# Technical Service Bulletin

## 91 Sound system: A-pillar speaker rattle, vibration or poor audio reproduction

91 20 55 2059143/1 April 8, 2020.

Model(s)	Year	VIN Range	Vehicle-Specific Equipment
A6, A7	2019	All	Not Applicable

**Figure 1.** Unwanted noise at the A-pillar speaker's electrical connection.

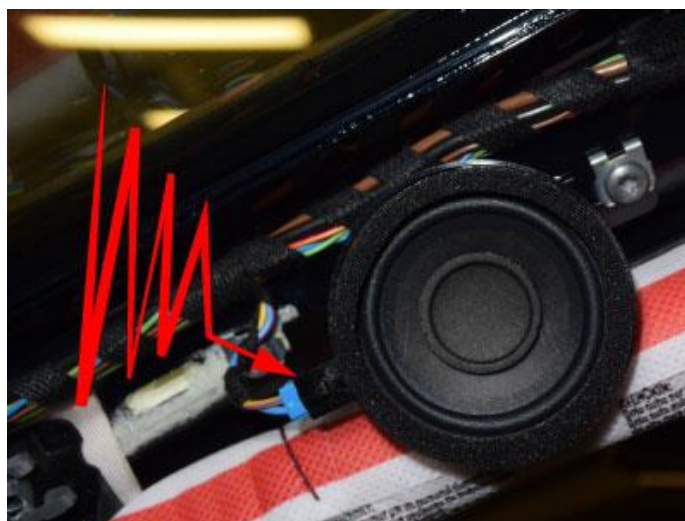
Tolerance between the speaker and harness connector is too high, creating unwanted vibration.

1. Verify that the noise is coming from the electrical connector at the A-pillar speaker (R276 or R277) (Figure 1).

Improved connector.

2. Ensure fasteners are properly torqued to 3.0Nm.
3. Update connector at speaker with improved connector 4B0 971 832 A.
